# Tram Extension, Edinburgh

Ocean Terminal to York Place  
Road Safety Audit Stage 3

Project number: 60651312  
AECOM Reference: RSA/316/S3-A

29 September 2023

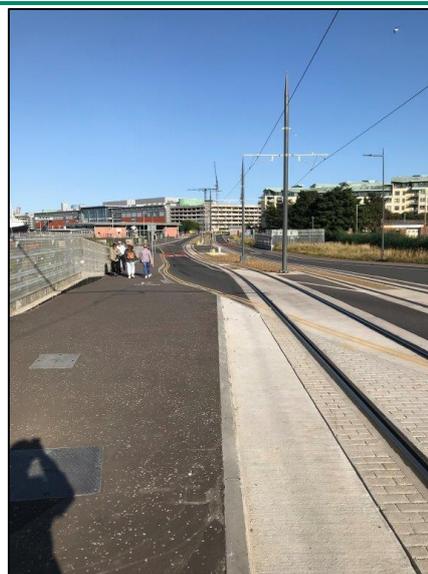
The Audit Team are concerned that this is still an issue and retain this recommendation to ensure that drainage is appropriate throughout the scheme extents.

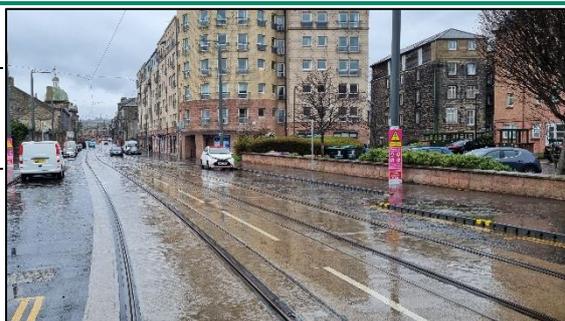
The Audit Team note the Designer's response comments, however there are still locations where cyclists can choose to travel and where there is a risk that they could cross the tram tracks at a very shallow angle and lose control as a result of a wheel entering the tram track. The above photo shows an example of this on Melrose Drive. The Audit Team retains the above recommendations.

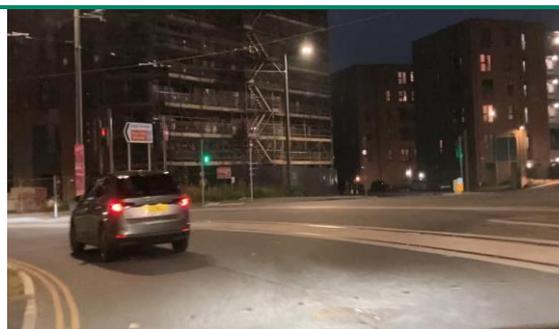
During the site investigation it was observed that the existing stop lines on Sandpiper Drive are very worn, as shown in the photograph above. From the plans provided to the Audit Team, it does not appear that these are to be refreshed / renewed.

Whilst the designer suggests that this location is out-with the scope of the scheme, it is still part of the public road network adjacent to the works and is still a risk to the traveling public. The Audit Team are still concerned that this is an issue and retain the previous recommendation.

Out of the scope

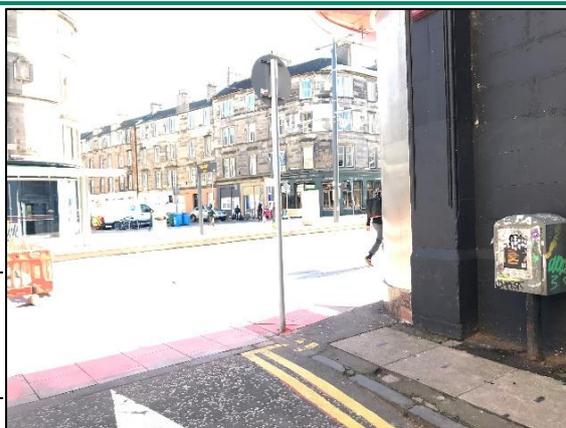
As it did not appear that this work has been completed, this recommendation is retained until such time as the work has been completed.

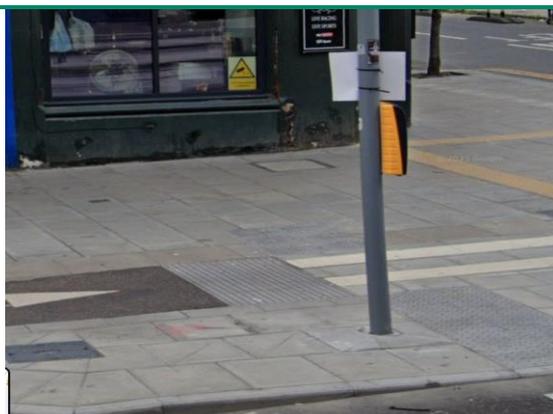
The Audit Team retain their belief that this is an issue. It was observed on site that drivers / riders tend to be focused on the pedestrian and cycle activity before crossing the continuous footway, they then require to look right to ensure a gap in the vehicular traffic before emerging onto Leith

Walk. This can result in drivers / riders failing to observe the traffic signals for the pedestrian crossing. There is also an issue as the Tram Lane sign further obscures the traffic signal head at this location as can be seen in the above photo. The previous recommendation is retained.

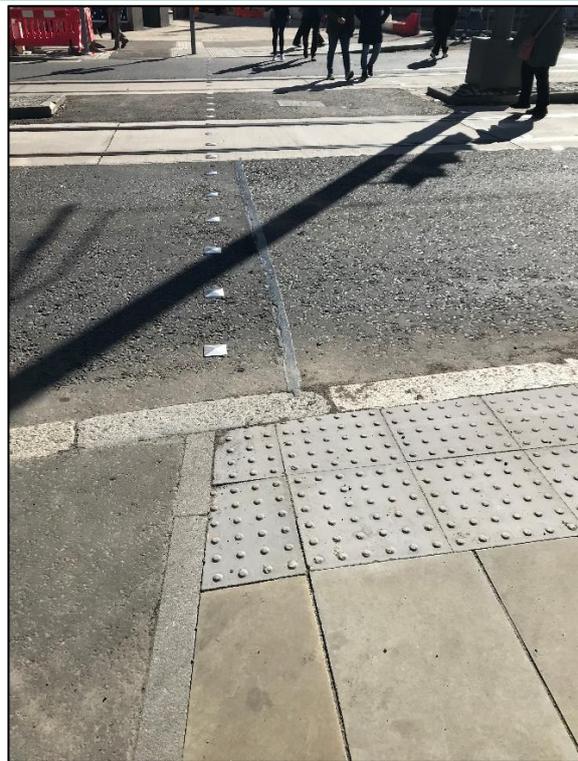
The Audit Team note the designer's response, however, are still concerned that there are a number of junctions where the layouts are very confusing. This applies to both those with good vision and visually impaired users. Police Scotland commented on the layouts after the Interim Road Safety Audit to suggest that they were rather confusing. The Audit Team therefore retain their belief that this is a problem and the recommendation from the Interim Stage 3 Road Safety Audit.

Layouts have been agreed with CEC through the road works working group and recorded through TQ's in CEMAR.

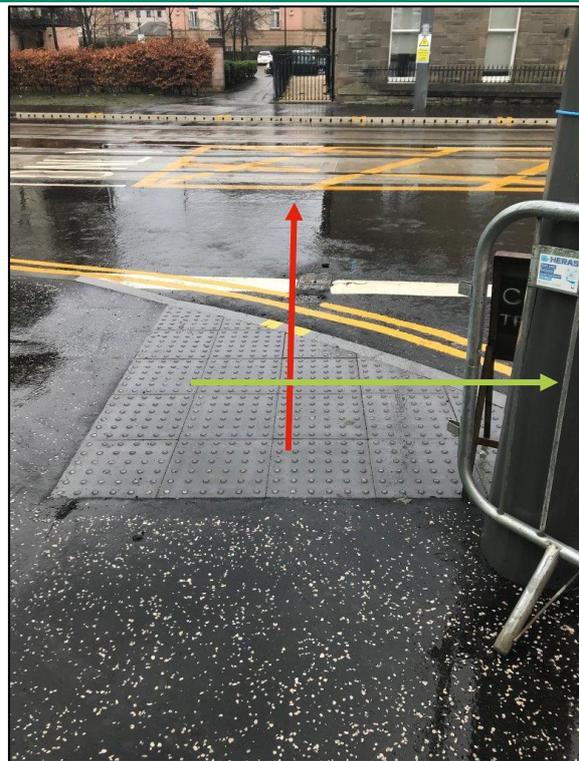
The Audit Team note the designer's response, however, even though this may comply with design standards, there is still a risk that a visually impaired pedestrian could miss the controlled crossing and cross the road where it is not safe to do so. The Audit Team therefore retain this recommendation.

None of these cases are applicable here.

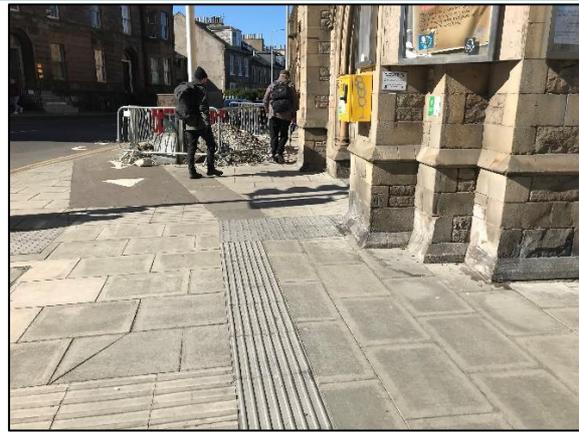
It was also noted that there are several additional locations where street furniture has been placed on the footway by businesses, which further restricts the footway width. The list below are further examples of where the footway width is compromised:

- Café Bellina just south of Montgomery Street – tables and chairs restricting footway width;
- Grocery shop just south of Albert Street – food displays restricting footway width;
- North of Pilrig Street west side – narrow footway
- Near foot of Leith Walk east side – narrow footway; and
- Near foot of Leith Walk west side – narrow footway.

The Audit Team retain the previous recommendation to ensure that the footway width is appropriate.

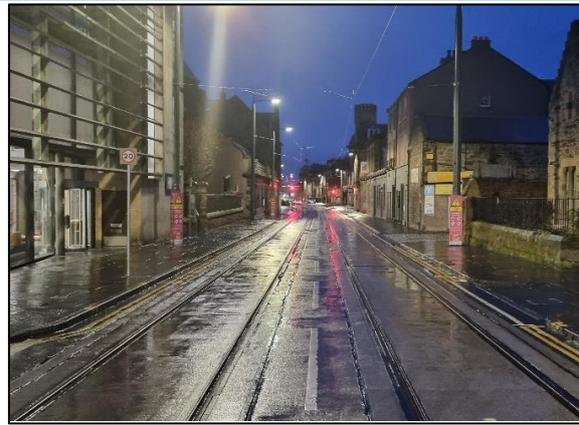
The Audit Team note the designer’s response, however, as this is still to be actioned, they retain the previous recommendation.

Agreed

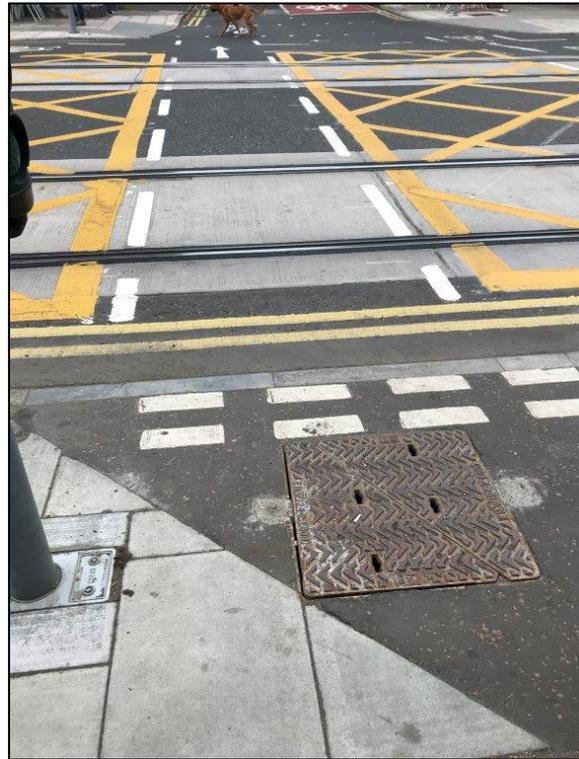
Given the depth of tactile paving provided, this could lead to visually impaired pedestrians being unable to detect it. This could lead to visually impaired pedestrians stepping into the cycleway out with the dedicated crossing points and potentially into the path of an oncoming cyclist.

It is recommended that the depth of the tactile paving is increased.

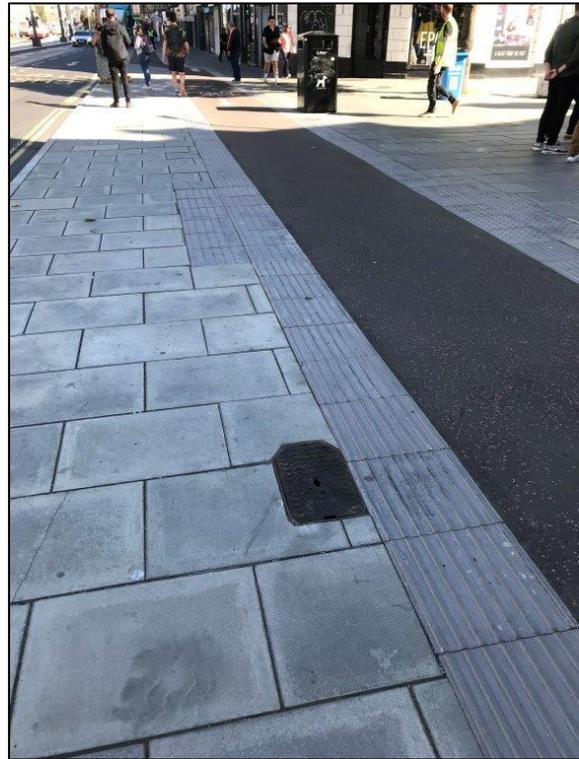
There is a risk that a vehicle travelling southbound could cross the central reserve in an attempt to access the car park and could collide with a tram or a northbound vehicle whilst doing so.

It is recommended that the signage facing southbound vehicles is removed.
